10 CFR 50.90
Docket No. 50-443
SBK-L-18074

Seabrook Station
Response to Request for Additional Information Regarding
License Amendment Request 16-03

Enclosure 1 provides NextEra Energy Seabrook's response to the NRC's Request for Additional Information (RAI) provided in Reference 6, concerning the License Amendment Request 16-03 related to Alkali-Silica Reaction.

Figure 1: The effect of ASR prestressing on onset of flexural cracking

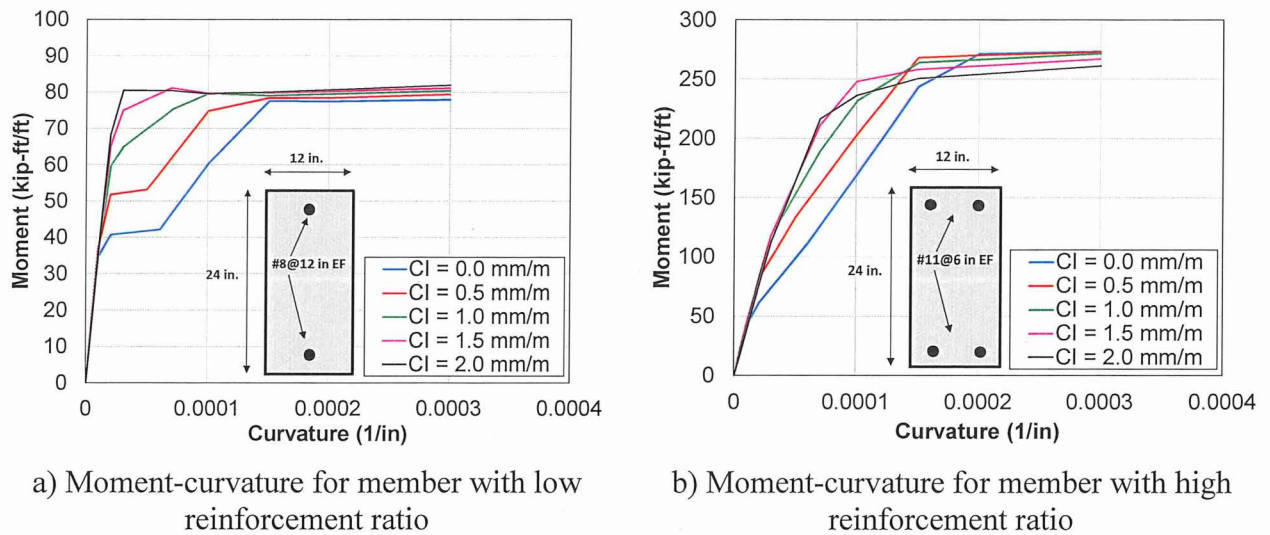
With regard to ASR effects on stiffness and the implementation of cracked section properties, explain how the relevant experimental data obtained on LSTP specimens are considered in the procedure in the Methodology Document (Section 4.4.5 and Appendix A, and supplements 4 and 5 in Section 5.6) for determining reduced stiffness (flexural, shear, and axial) in implementing cracked section properties. Explain whether and how the ASR prestressing effect is applied to the calculation of cracking moment, cracking strain, and shear strain for ASR-affected members, and provide supporting technical basis.

The member is first pre-loaded with ASR expansion values corresponding to Cracking Index (CI) values of 0.0, 0.5, 1.0, 1.5, and 2.0 mm/m. The applied moment on each member is then increased to simulate the section moment-curvature behavior for a member with different level of CI value. The member is analyzed using fiber modeling where concrete fibers are modeled by nonlinear concrete behavior in compression and tension, and reinforcement is also assigned a bilinear elastic-plastic behavior. Figures 1(a) and 1(b) show the increased moment for onset of flexural cracking with increasing ASR expansion (increased CI values). This is consistent with the results of the MPR/FSEL LSTP that attributes the increased stiffness to a delay of flexural cracking onset due to ASR-induced prestressing.

Table 1 shows that the cracking moment increases with increasing ASR expansion level, which is consistent with the results of parametric studies presented in Figure 1 and with the conclusions of the Reinforcement Anchorage Test Program.

Figure 4. Flow Chart Schematic for Computing Lateral Concrete Backfill Pressure due to ASR.

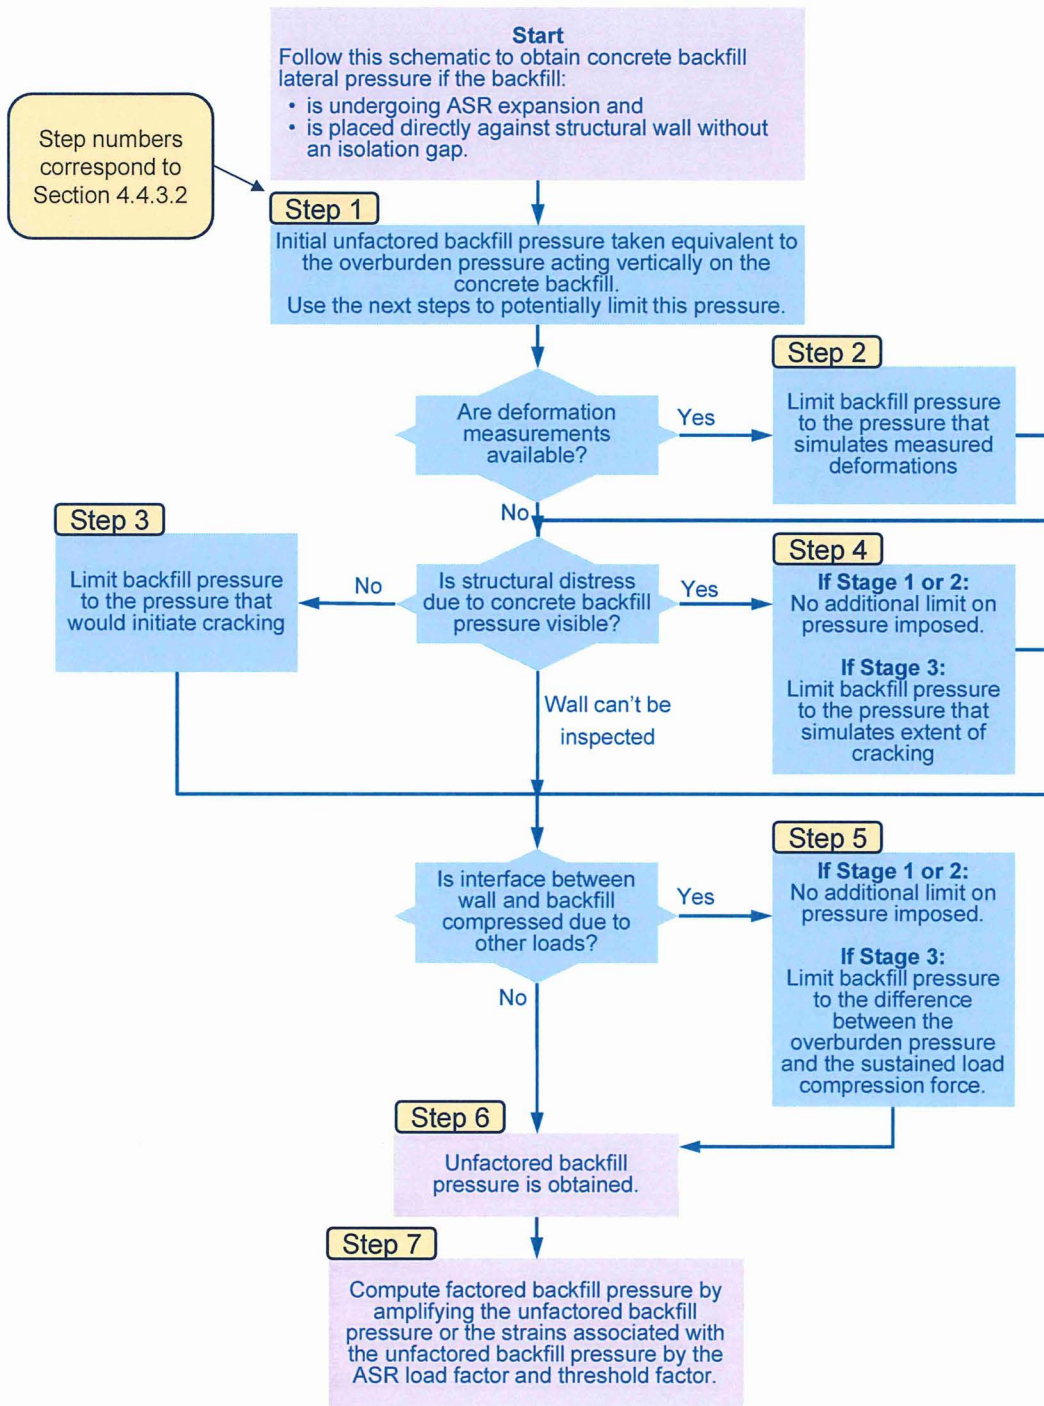
Explain if the results of this calculation will result in a revision to the MD. If the MD will be revised, provide the revision with an explanation of the technical basis of the changes. Also, explain whether applicability of the revised proposed methodology is specific to the electrical tunnel structure, or whether it is generically applicable to any structure with embedded walls against concrete backfill with no observed signs of distress.

Methodology Document Section 4.4.3.2 has been revised to provide an alternative approach to evaluate embedded walls which are expected to first form flexural cracks before shear cracks under increasing lateral load and currently show no sign of visible structural cracking. This alternate method defines the method for estimating the lateral pressure induced by ASR expansion of concrete backfill to be applied to these types of walls. This alternative method allows the concrete backfill pressure to be reduced under the following conditions:

If field observations of the wall show no signs of distress, then the unfactored backfill pressure may be reduced and be limited to the pressure that would initiate observable distress in the wall. In most cases, distress would be observable as flexural cracking. Concrete backfill ASR pressures acting laterally on walls shall be determined by the steps discussed in Section 4.4.3.2 and schematically shown in Figure 4.
